County of Loudoun
Department of Planning
MEMORANDUM

SUBJECT: SPEX 2009-0032, SPMI 2009-0010 and CMPT 2009-0011
Arcola Substation

To: Sophia Fisher, Project Manager
From: Maria Figueroa Taylor, Fire-Rescue Planner
Date: March 23, 2010
Subject: Arcola Substation, second referral
SPEX 2008-0032, SPMI 2009-0010 & CMPT 2009-0011

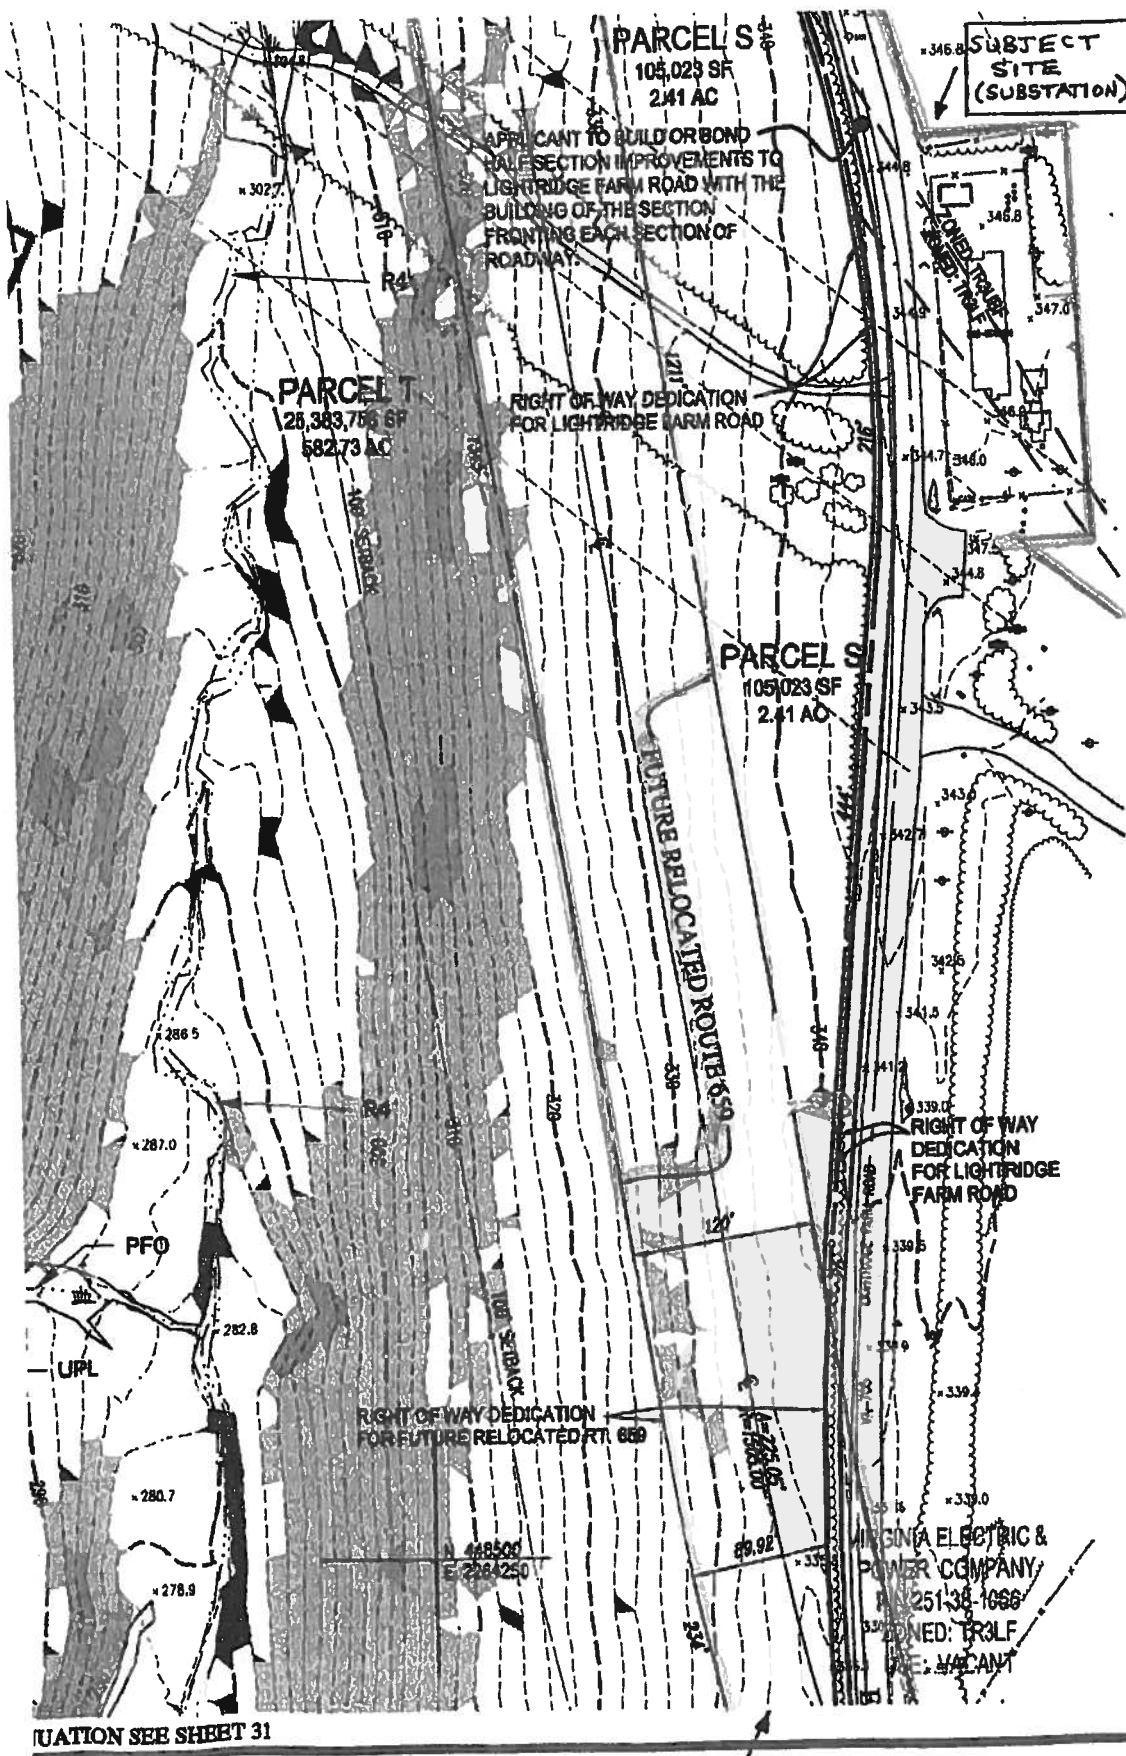
2. **Initial Staff Comment (1st Referral):** The Applicant should provide a cross-section of existing Lightridge Farm Road in the vicinity of the site, showing the road's location within the existing ROW. The plat should be revised to clearly depict the location of the existing roadway (including centerline) and ROW boundary along the frontage of the subject site. Depiction of the existing ROW boundary will aid in determining whether any additional ROW for the ultimate location of Northstar Boulevard can be provided along the frontage of the site given the existing substation's close proximity to the existing roadway.

Applicant's Response (March 10, 2010): The additional sheet 5 has been incorporated to show the existing road centerline and right of way. A detail also showing the centerline, edge of pavements right of way and existing fence of substation has also been shown in this same sheet 5. Please note that the existing fence is about 6" from the right of way. This substation was built in the 1960s where no setbacks were required. The fence is 15' away from the existing electrical structures based on safety regulations and vehicle access for maintenance. There is also an existing control building adjacent to the fence. With all of these described items it is impossible for any additional right of way dedication in this area. Further, we submit that requiring a dedication for the ultimate location of Northstar Boulevard would be a violation of Virginia and Federal law because the need for the dedication would in no way be roughly proportional to the 1-vehicle trip per month impact of the proposed substation addition.

Issue Status: **Issue resolved.** OTS did not request additional ROW from the Applicant, but rather a cross section depicting the location of existing Lightridge Farm Road within the existing ROW, as it was not clear from the Applicant's Special Exception plat (dated November 20, 2009) where the ROW boundary was located relative to the existing substation. The additional plat sheet and cross section (revised February 3, 2010) provided by the Applicant clearly depict the existing conditions and are appreciated.

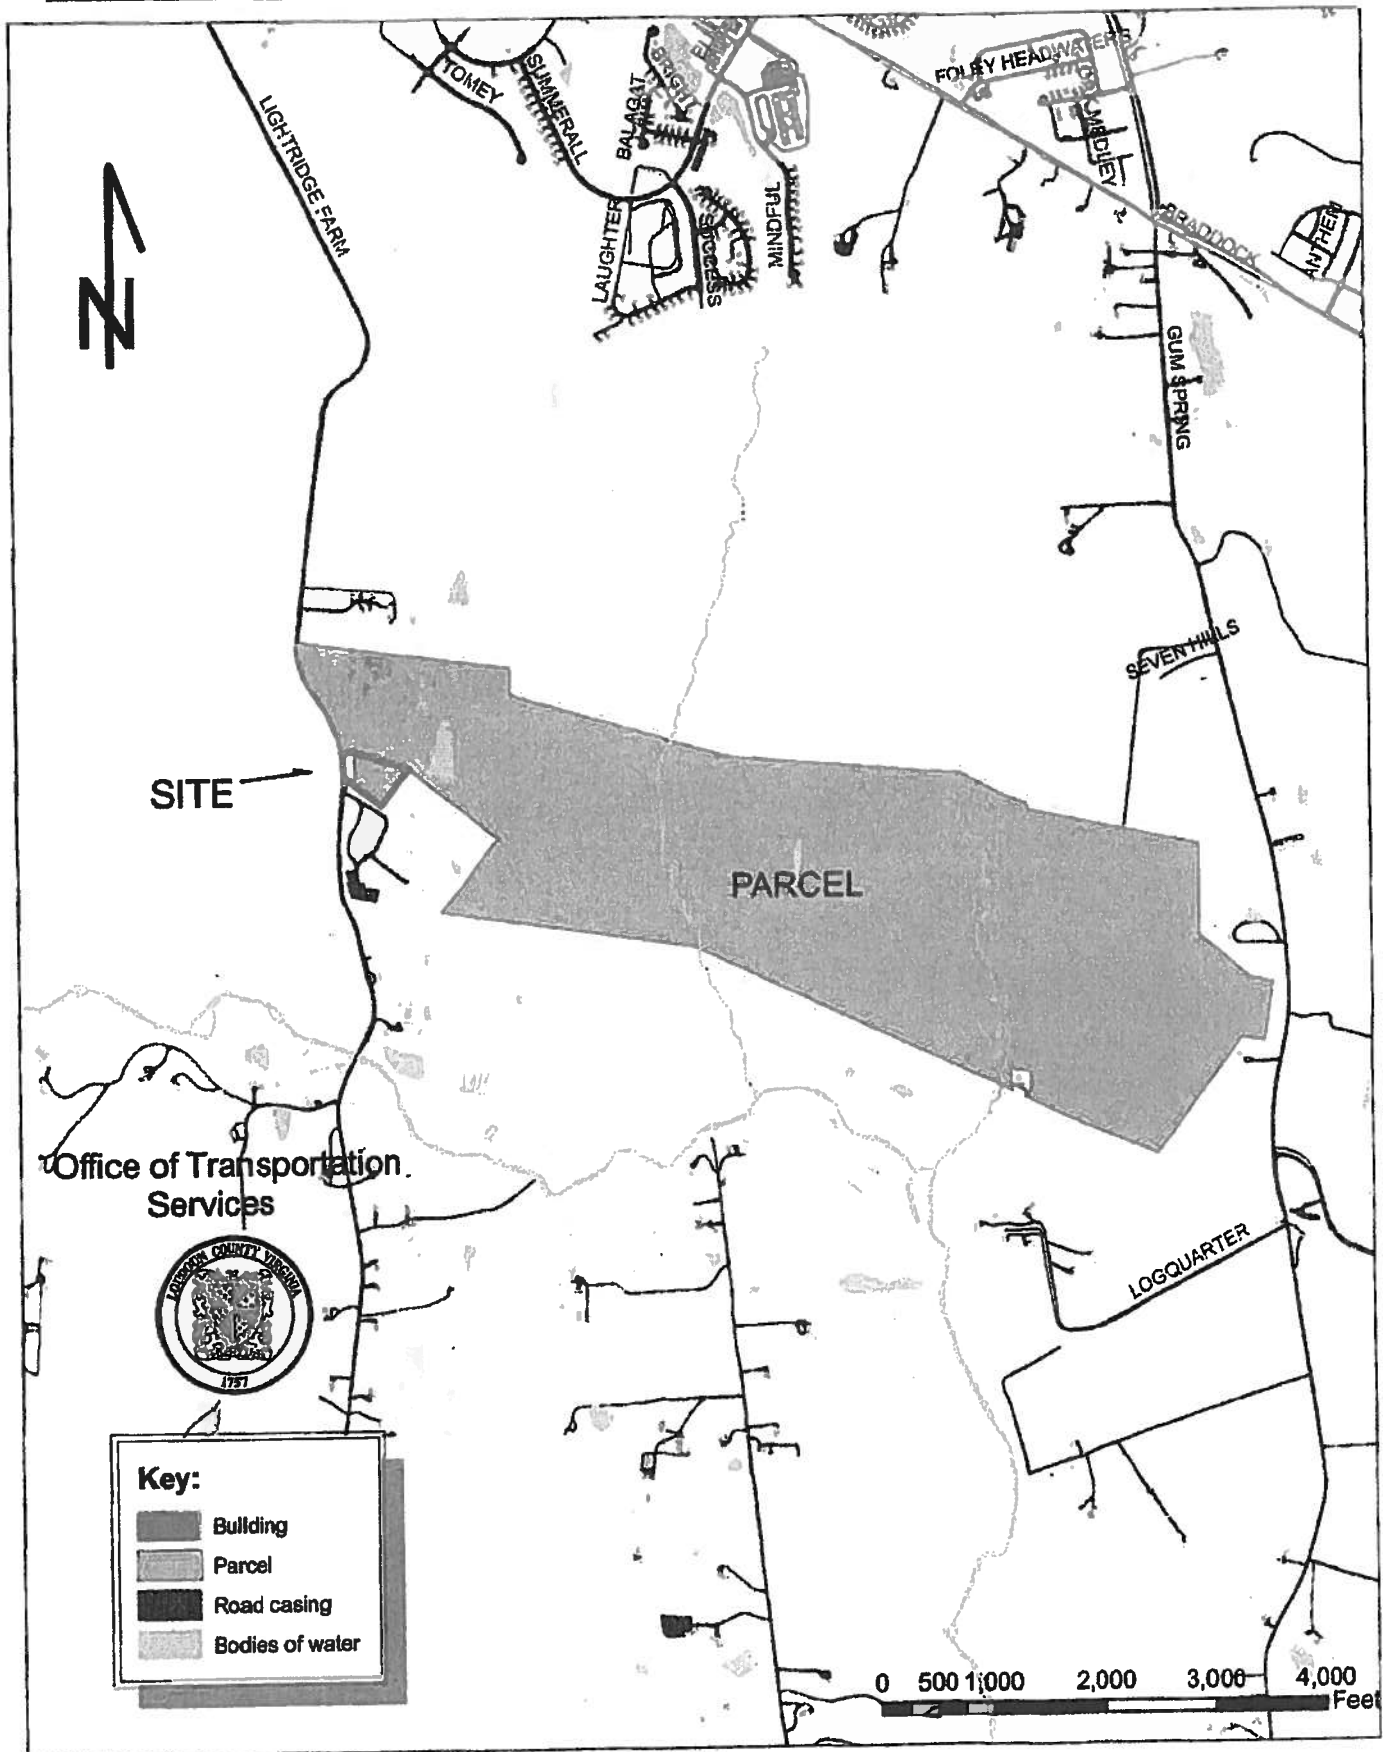
1. The Applicant should indicate whether there will be any changes/modifications to the existing site entrance, and confirm that the entrance meets/will meet applicable VDOT entrance requirements.

2. The Applicant should provide a cross-section of existing Lightridge Farm Road in the vicinity of the site, showing the road's location within the existing ROW. The plat should be revised to clearly depict the location of the existing roadway (including centerline) and ROW boundary along the frontage of the subject site. Depiction of the existing ROW boundary will aid in determining whether any additional ROW for the ultimate location of Northstar Boulevard can be provided along the frontage of the site given the existing substation's close proximity to the existing roadway.

3. According to the 2001 Revised CTP, the planned alignment of Dulles South Boulevard traverses the larger 379-acre property (MCPI # 208-27-0686) owned by South Auburn Limited Partnership, though completely outside of the area subject to these applications. Consideration must be given to the alignment of this planned roadway in future development of the larger parcel.
